COMMITTEE REPORT

2 July, 2015
08
15/1704

LOCATION: 19 Carlisle Road, Kilburn, London, NW6 6TL

PROPOSAL: Erection of rear dormer window, replacement of rear rooflight and installation of a conservation type rooflight to the front roof slope.

Existing and Proposed Front Elevations

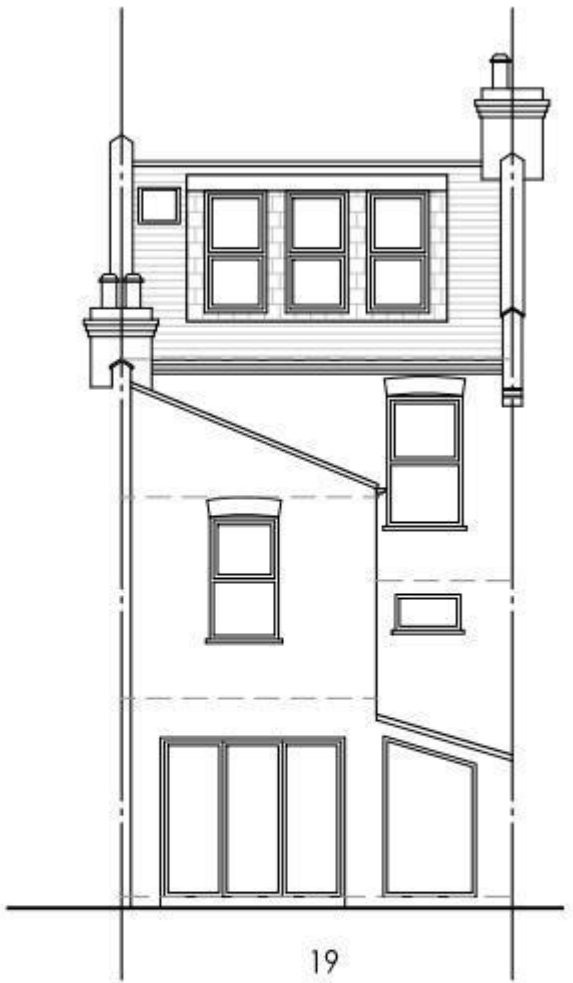
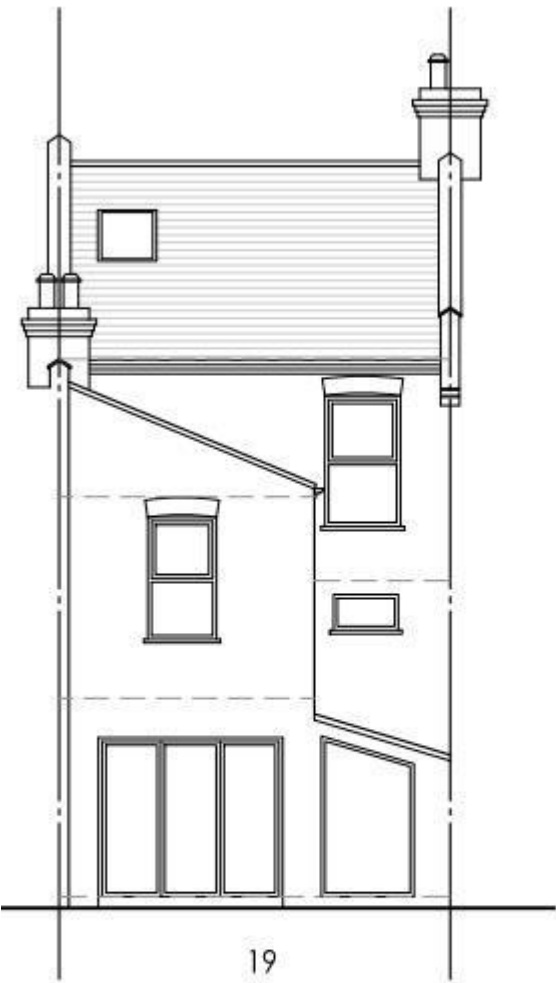
1. The recently adopted Queens Park Conservation Area Design Guide (2013) sets out what extensions and alterations to dwellings can normally be considered acceptable in the Conservation Area. Section 3.1 of the guide states that rooflights are not permitted on the front elevation of dwellings. The proposal includes the insertion of a conservation-style rooflight on the front roof slope of the dwelling.

2. Since the adoption of the Design Guide front rooflights have not normally been permitted in the Queens Park Conservation Area. However, representations have been received from the Queens Park Residents' Association during the course of this application that has confirmed that they do not object in principle to the insertion of single conservation-style rooflights on front roof slopes, despite what the Design Guide says. Whilst the current Design Guide does not permit front-facing rooflights, Officers recognise the importance of engaging with the local community in developing and implementing design guidance and in this case it is clear from the representation from the Residents' Association that they are content for a particular decision to be taken here and this has been taken into account.

3. The proposed rooflight would be a conservation-style rooflight and is considered relatively modest in size (1m x 0.6m) and would align with the central window of the bay window feature below. The proposed rooflight is considered to fit comfortably on the front roof slope and is not considered to result in an unduly cluttered appearance.

4. In light of the above, on balance, it is considered appropriate in this instance to make a recommendation for approval to Members for this application for the reason set out above. What this effectively means is that the Planning Committee would be allowing an interim change to the interpretation of the Queens Park Conservation Area Design Guide to allow for single, appropriately sized and positioned conservation-style rooflights on front roof slopes until such time as the Design Guide can be formally amended to reflect the recently confirmed views of QPRA.

Existing and Proposed Rear Elevation

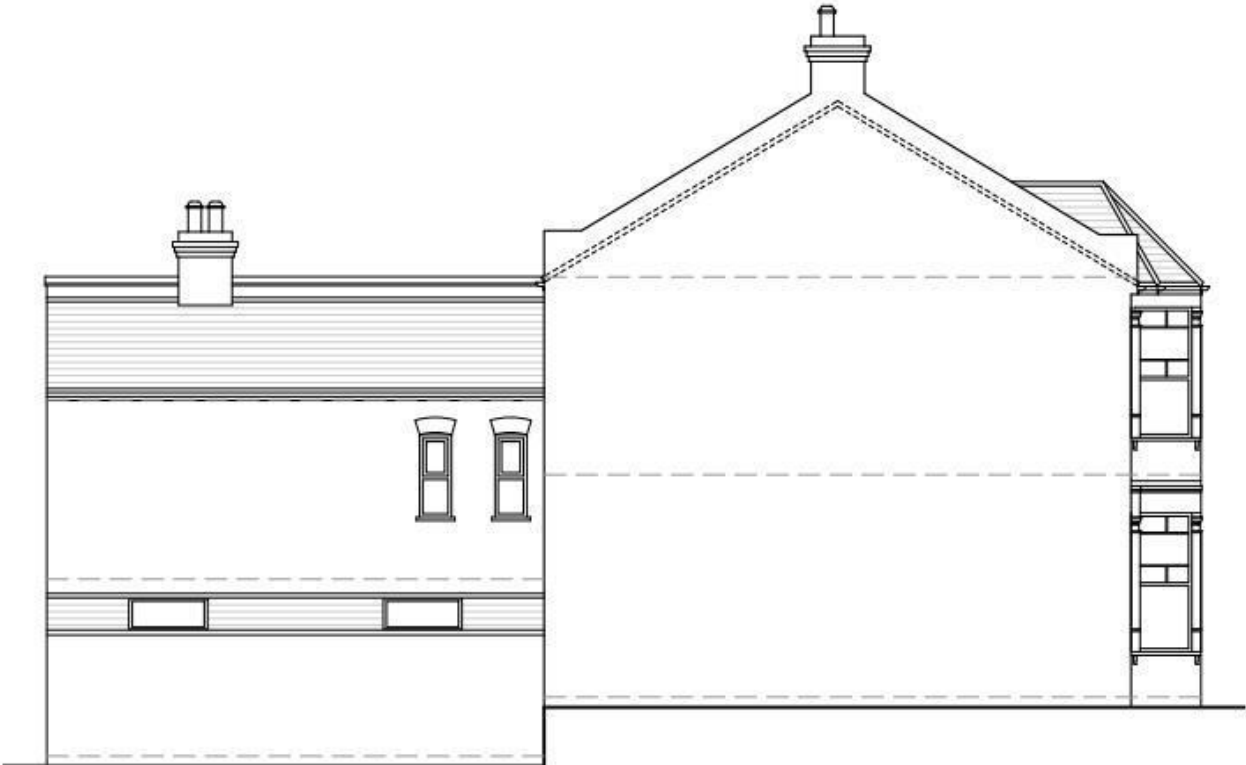
6. The proposed rear dormer in this instance would be two thirds the width of the rear roof slope, would be set-down 0.3m from the ridgeline of the dwelling and set-back 1m from the eaves. The dormer would be predominately glazed with sash-style windows and is considered a proportionate addition which sits comfortably on the rear roof slope. The rear dormer is therefore considered to comply with the guidance set out in the Design Guide and is considered visually acceptable. As explained above the dormer window was granted planning permission through application 15/1682 but that application did not include a front rooflight which is the reason for this second submission.

7. The host dwelling benefits from an existing rear rooflight and the proposal would include the replacement of this rooflight which would sit alongside the dormer on the rear roof slope. The rear rooflight is modest in size and is considered an acceptable addition to the rear roof slope of the dwelling.
